MEMORANDUM

From: Luke Hanson, Public Works, Capital and Transportation Planning

DATE: 6/2/2015

SUBJECT: Summary of public comments received on the proposal to incorporate bicycle facilities into Ramsey County mill and overlay projects on Cleveland Avenue, Lexington Parkway, and Front Avenue.

OPTION 3 - THE WARD 3 BIKE LOOP

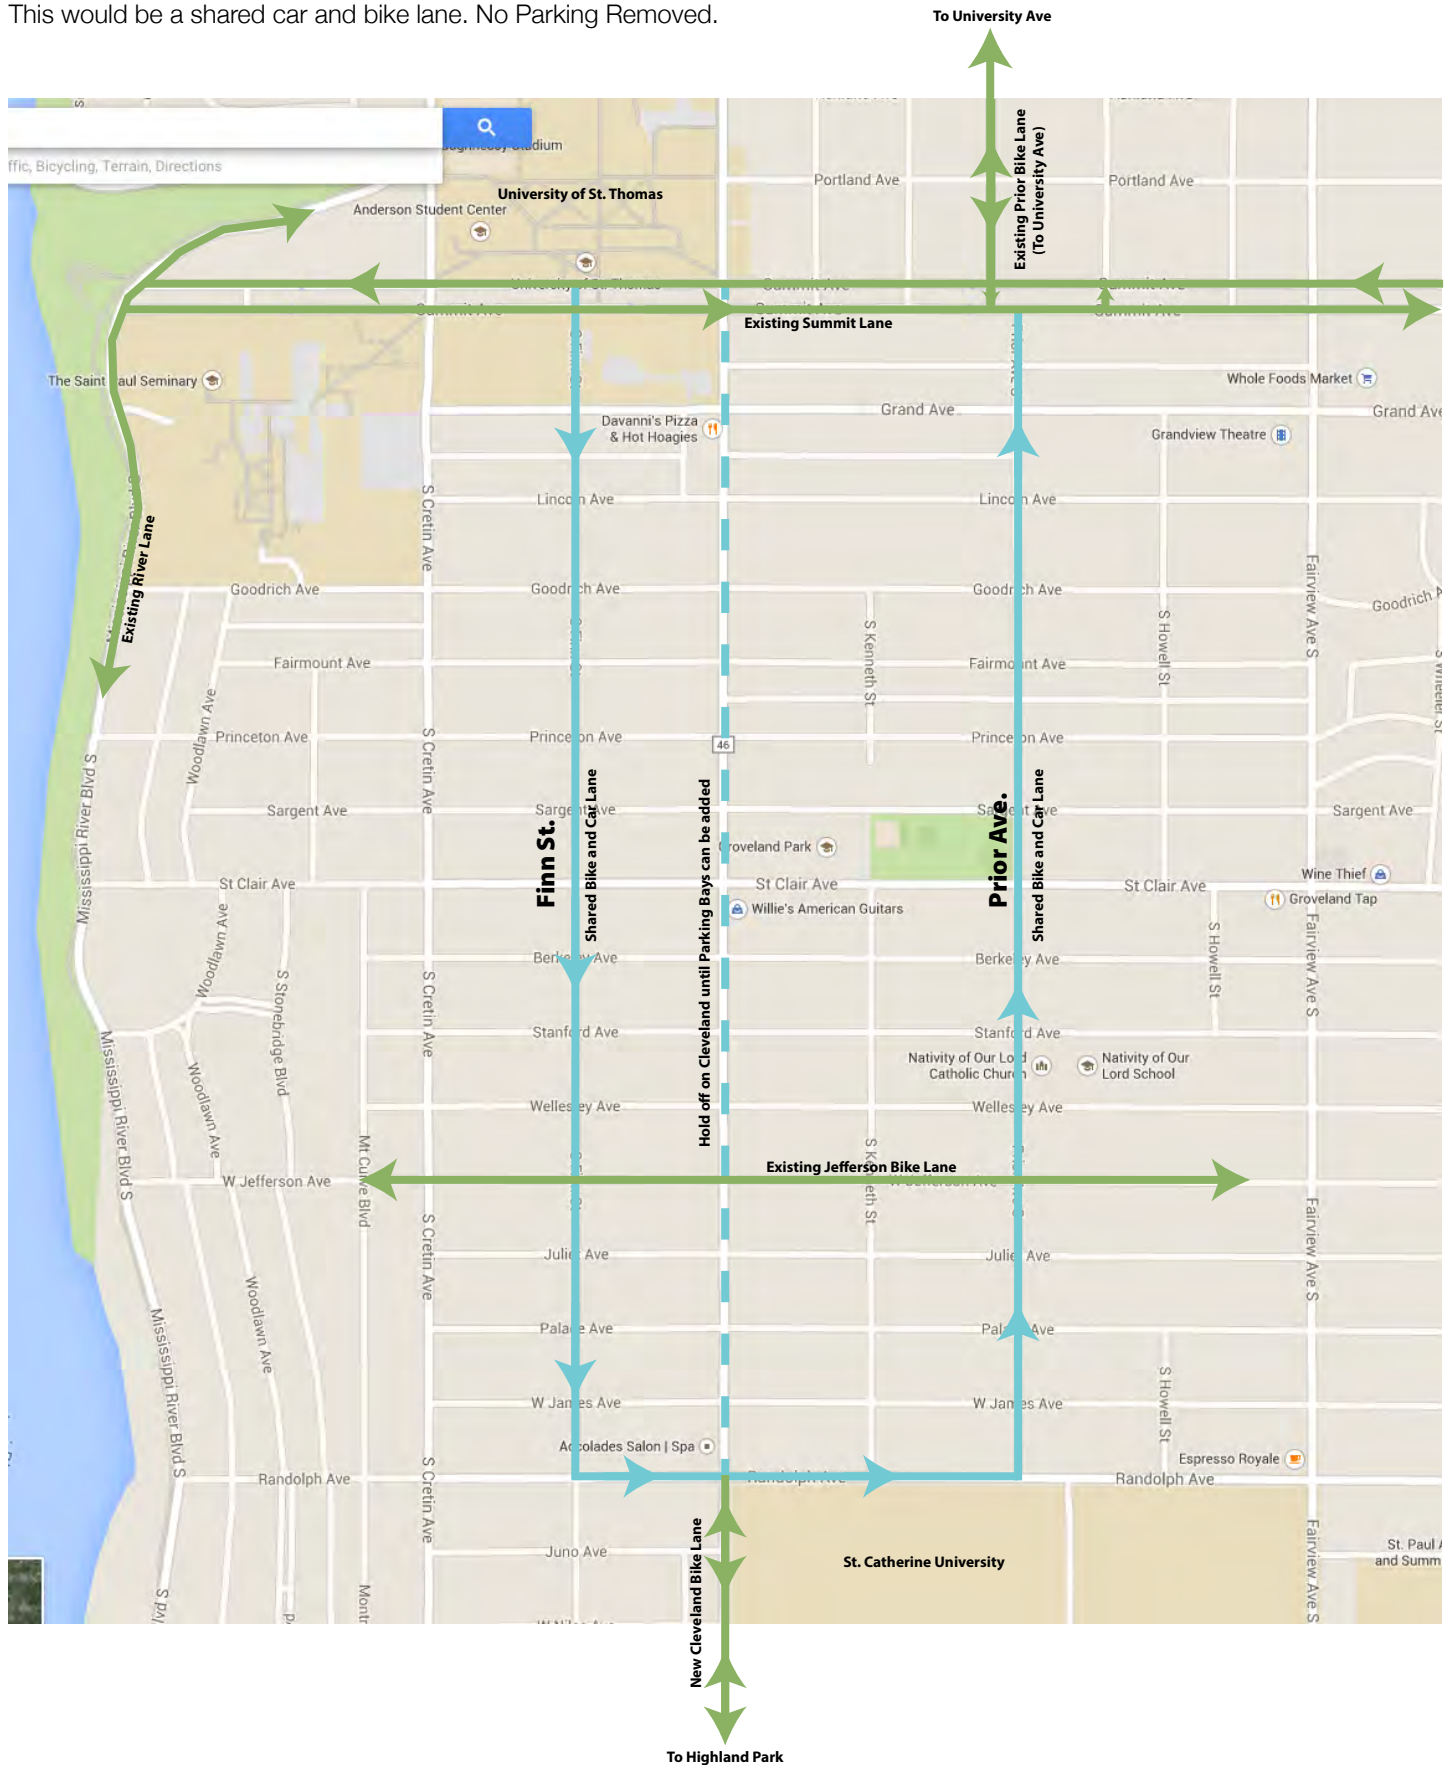
Using Finn Street and Prior Avenue as a temporary bike route until parking bays can be done on Cleveland.
Finn for South bound bike traffic and Prior for North bound bike traffic.
This would be a shared car and bike lane. No Parking Removed.

This map I made shows where parking and parking restrictions exist for one block on either side of Cleveland Ave.

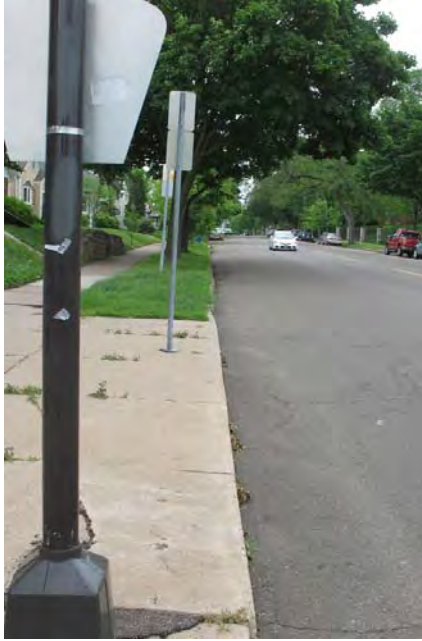
The city's parking utilization study at <http://stpaul.gov/DocumentCenter/View/78422> showed the only heavily used parking was the northern two blocks (largely by UST students who don't want to pay for on-campus parking), near Kehilat Sar Shalom Temple at Sargent for weekend Shabbat services, and the last block between James and Randolph.

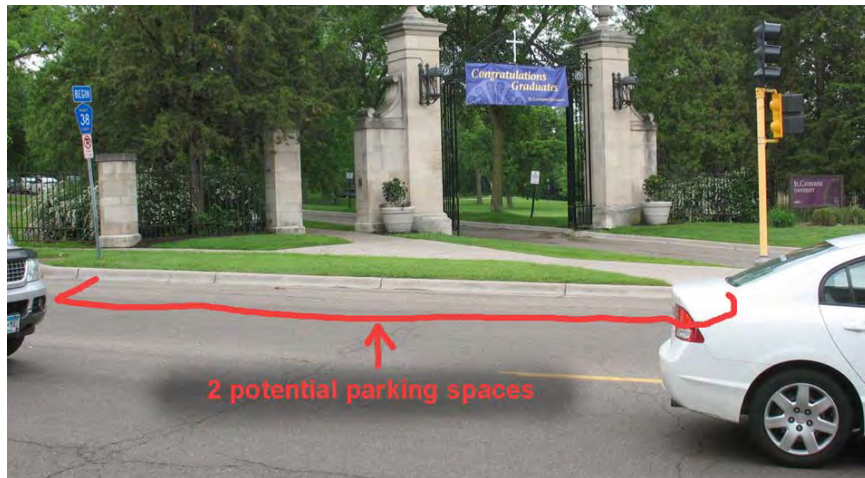
Two spaces on Randolph already carry 30-minute parking restrictions to encourage turnover for businesses on that corner and additional spaces could be designated as 30-minute, 1-hour or even 2-hour spots at certain times. This would increase parking availability during the day or even in the evenings for restaurant-goers.

Across Cleveland from Luci Ancora, there is room for two on-street spaces on Randolph in front of St. Catherine University, if the city chose to allow parking there. This would make up for two of the lost nine parking spaces.

Next to the Accolades Spa 15-space parking lot, is an unused driveway that can provide an additional 2-space parking bay. It is currently useable as-is but could be officially signed and proper curb-cuts added at a later date. This would make up for an additional 2 of the 9 lost parking spaces.

Finally, the sidewalk in front of Kurt and Angela Chandler's building is wide enough for a 5-space parking bay. This would replace the remaining 5 of the 9 lost parking spaces. If the bay can't be constructed as part of this street repaving project, there could be sharrow pavement markings in lieu of bike lanes between Randolph and James, *pending construction of this bay at some designated, future date.*

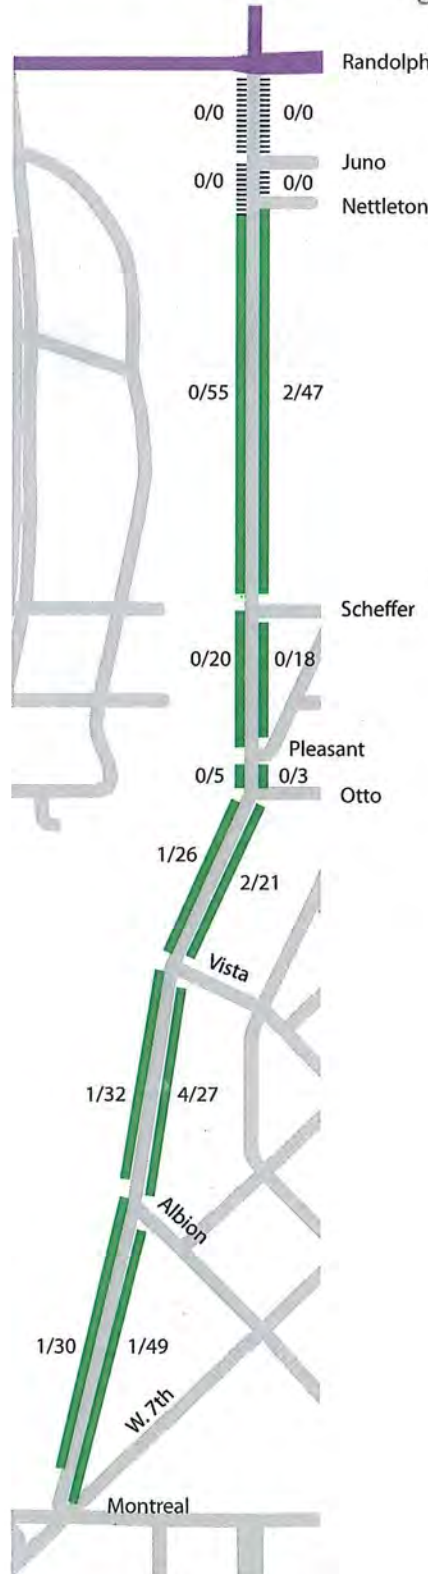
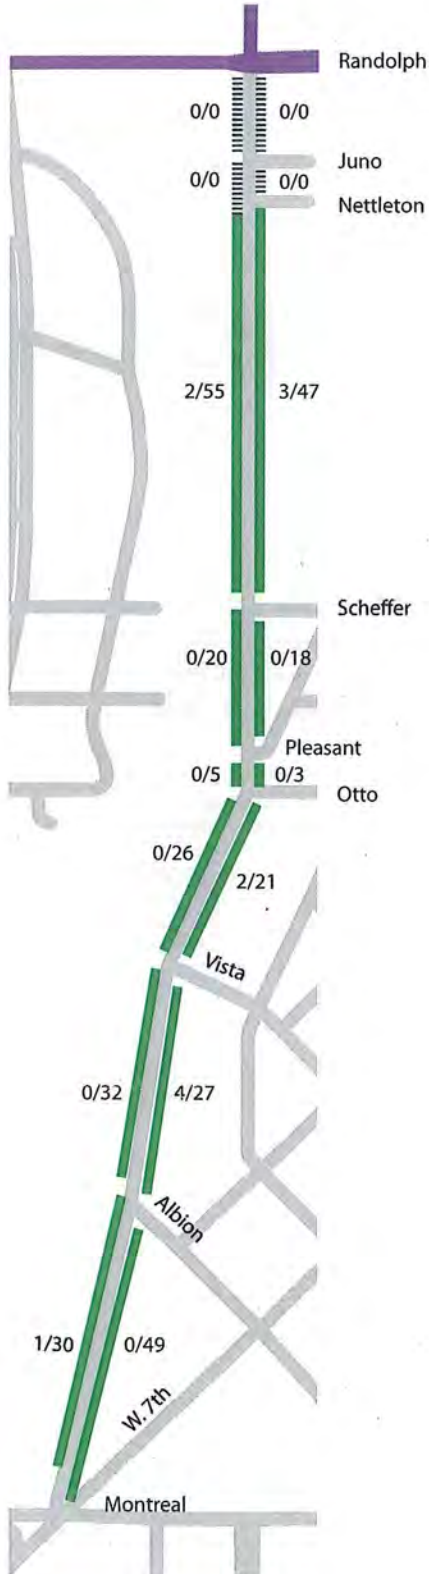
1) Significant increase in hazards & danger for bicyclists & traffic in travel lanes.

Your report discloses monitoring results for parking, but does not disclose monitoring for bicyclists. None (or few) bicyclists go northbound on Lexington Parkway because of the steep incline. Those who try tend to wobble which creates a hazard for them & the northbound drivers who would have to contend with narrower lanes, for themselves & on-coming traffic which includes garbage trucks (moving or parked), delivery trucks (moving or parked), & street repair/maintenance equipment, etc.

2) Regarding parking: increased inconvenience for those who currently do park on the southbound side of the street, especially when it snows & snowplows leave piles of snow on the sidewalk; and also when it rains, with flowing water curbside.

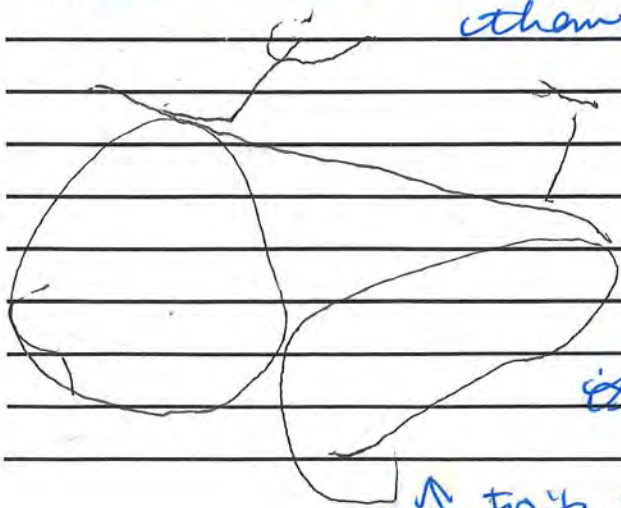
I support bike facilities on Lexington (and Cleveland) if it is possible to consider physically separated bike lanes on Lexington or even a 2-way cycle-track?

Bike facilities & narrower lanes will help lower MV speeds & calm traffic.
